ADDENDUM NO. 1– Portage Public Schools – Woodland Elementary – Asphalt & Landscaping

July 24th, 2026

The following items are changes, clarifications, corrections of errors, etc., with respect to the Contract Documents previously issued. This addendum shall be a part of the Contract Documents.

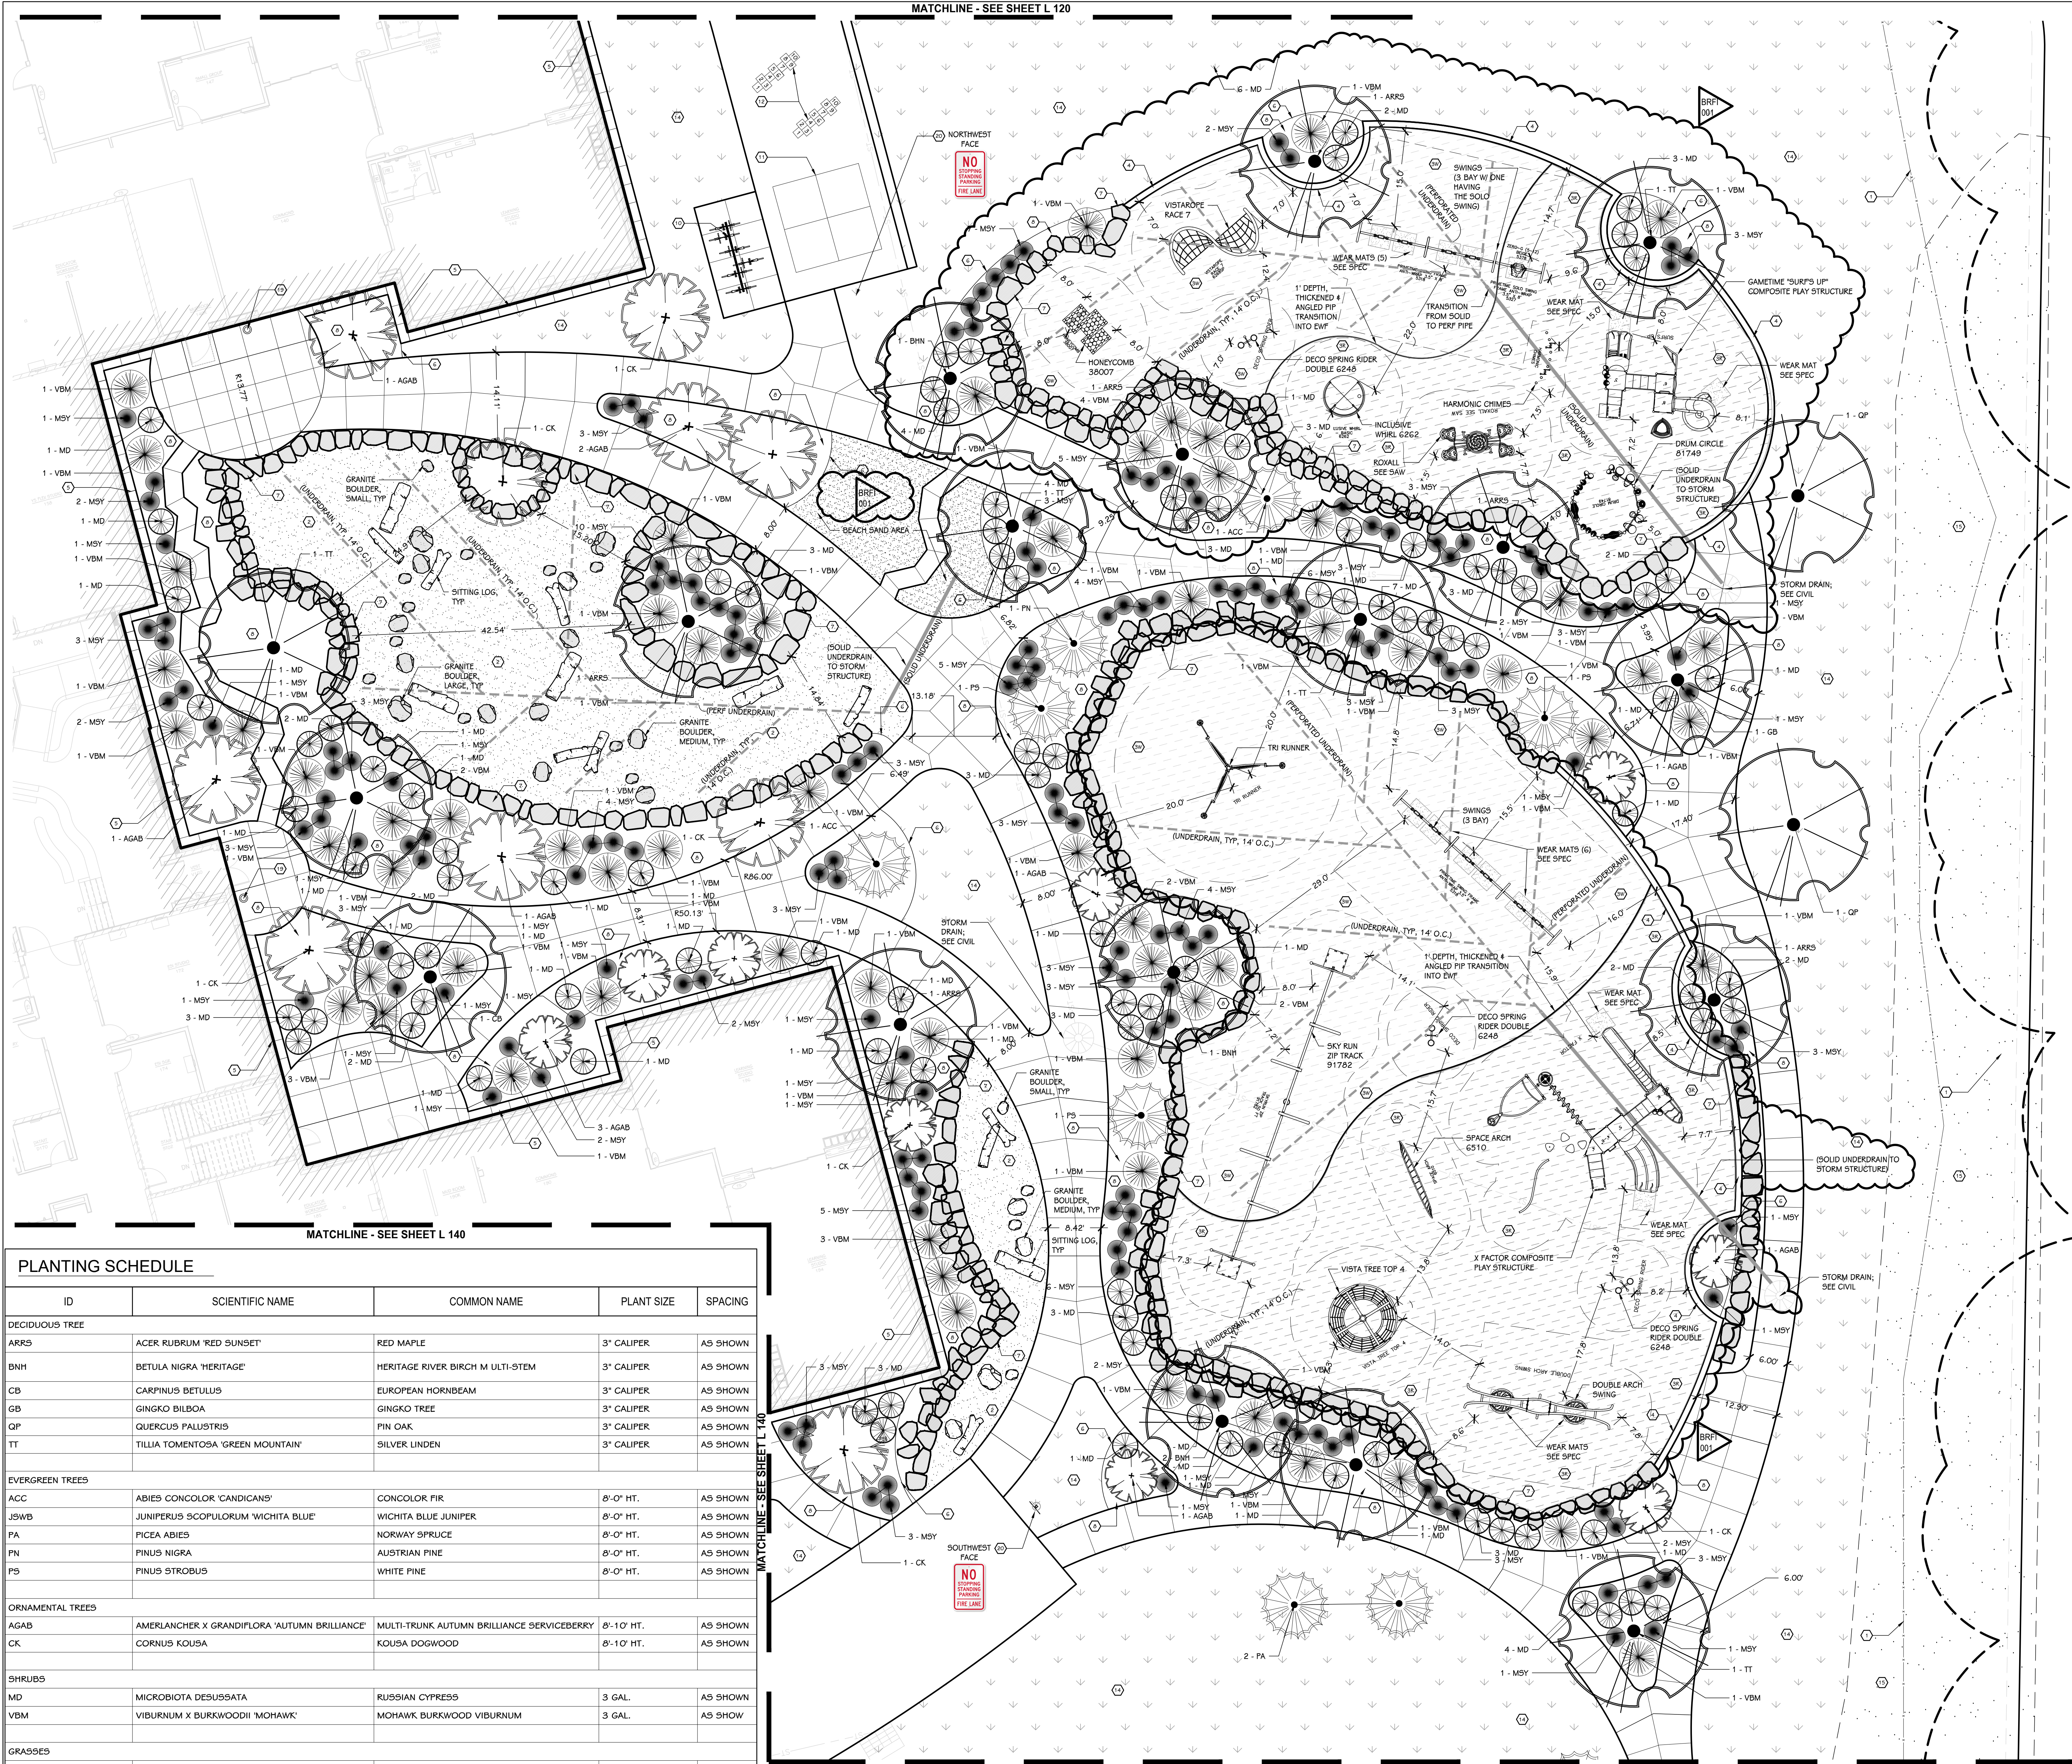
* The landscape drawings call for ledge stone boulders. Can you please provide a supplier, color and detail.
* I see that there is 1 of the ledgestone wall on sheet C-300 but L-130 shows 5 ledgestone calls. Can you please confirm which is correct.

Reissued sheets L 130 and L 200 (attached) clarify the ledgestones installation. In addition, the play equipment, surfacing, and underdrainage have been revised to meet recent Owner requested changes.

18 LEDGESTONE BOULDERS
SCALE: 1/2" = 1'-0"

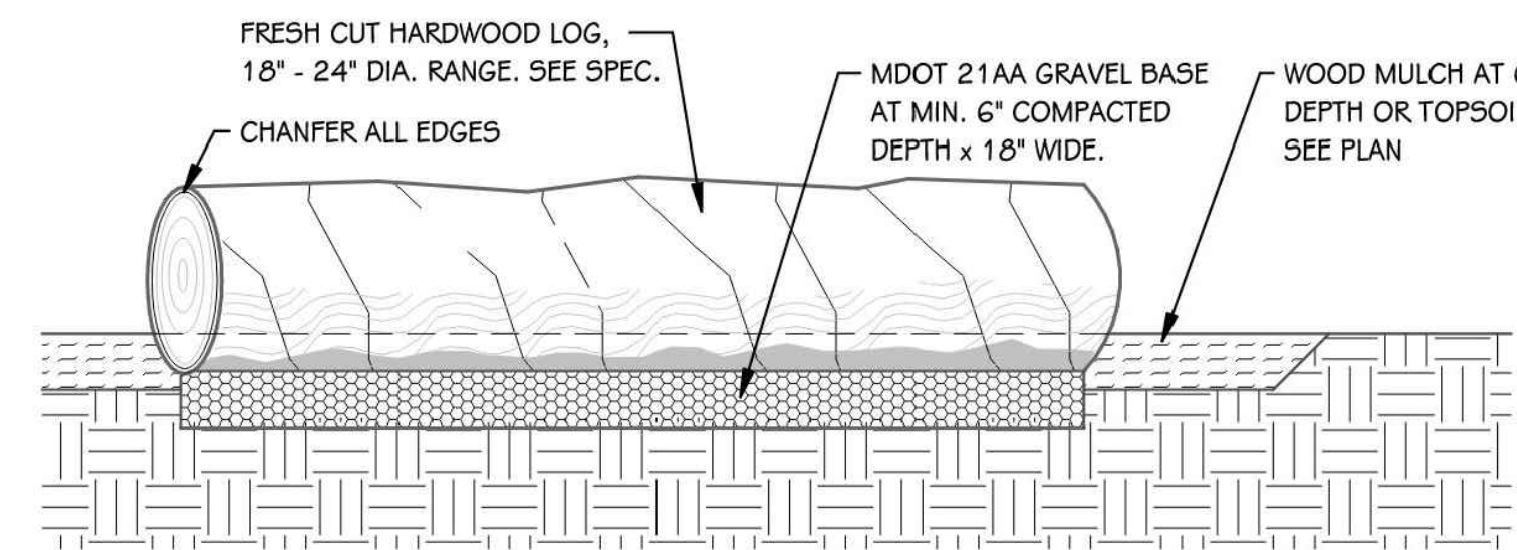
Kayla Mielke (TowerPinkster (Kalamazoo)) Responded Fri Jul 24, 2026 at 08:29 am EDT Ledgestone boulder detail added to reissued sheet L 200 in BRFI 001. Specifics of size, colors, and basis of design features are answered in BRFI 001 response of today's date. Granite boulders come in three sizes based on minimum dimensions indicated in at least two axes: Small (18" - 24" dia.), Medium (24" - 36" dia.), and Large (36" - 60"). Small = 18" - 24" dia. Medium = 24" - 36" dia. Approximately 25% of 'bottom' of each to be recessed in grade prior to the addition of bark mulch around them. Wood log detail added to reissued sheet L 200 in BRFI 001. Lengths are to be approx. 6' min to 9' max length. All loose bark, splintered cracks, and other sharp or loose features shall be removed, ground down, pulled off, or otherwise rendered with as few unexpected sharp edges as possible. TowerPinkster 07/24/2026 C. Newhouse BRFI 004 Boulders and Logs - RESPONSE.pdf

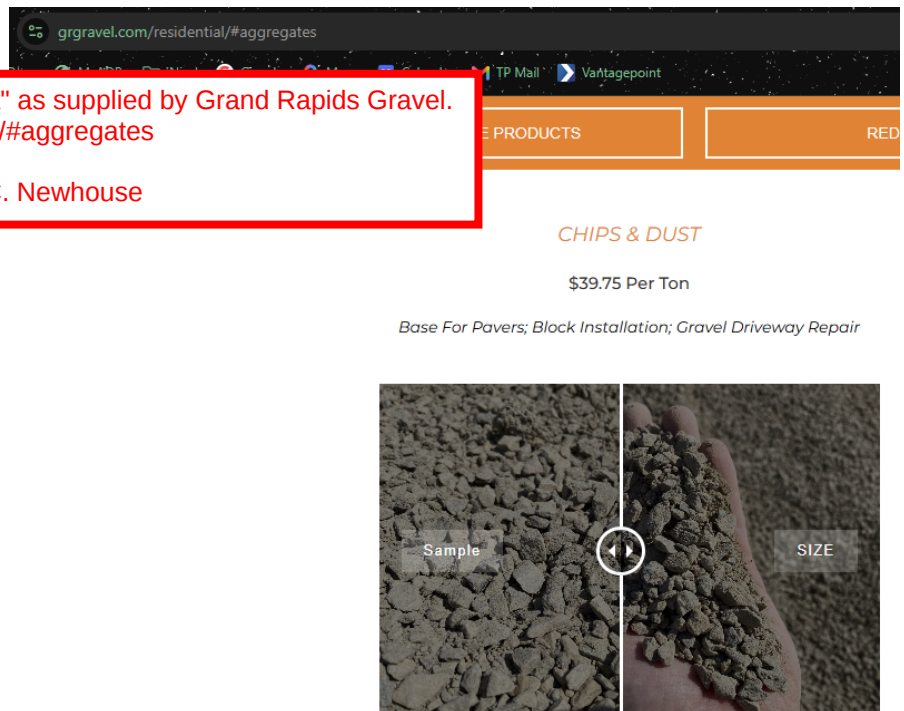
Stone Dust Spec	Pre-Bid Landscape & Asphalt - RFI 011	Closed			None	07/22/2026	Anastasia Wojcik	Mielke, Kayla (To...	07/25/2026	07/24/26						Bidding	Mike Hoeksema (Owen-Ames-Kimball Co. - Kalamazoo)	No
Q: Anastasia Wojcik Sent Wed Jul 22, 2026 at 11:49 am EDT Can you please provide a spec for the stone dust areas? A: Kayla Mielke (TowerPinkster (Kalamazoo)) Responded Thu Jul 23, 2026 at 10:30 am EDT Basis of Design: "Chips & Dust" as supplied by Grand Rapids Gravel. https://grgravel.com/residential/#aggregates TowerPinkster 07/23/2026 C. Newhouse BRFI 011 Stone Dust Spec - RESPONSE.pdf																		
Passageway ductwork 280H	RFI 089	Open	DHE Plumbing & Me...	Mielke, Kayla (To...	Wohlgenmuth, Tom (DHE Plumbing & Mechanical)	07/22/2026	Mike Hoeksema	Mielke, Kayla (To...	07/25/2026			TBD	TBD			Course of Construction	Dustin Healy (DHE Plumbing & Mechanical), Percy Haywood (Allied Electric Inc), Anastasia Wojcik (Owen-Ames-Kimball Co. - Kalamazoo), Chris Mankowski (Plante Moran), Bradey Waters (Allied Electric Inc)	No

Basis of Design: "Chips & Dust" as supplied by Grand Rapids Gravel.
<https://grgravel.com/residential/#aggregates>
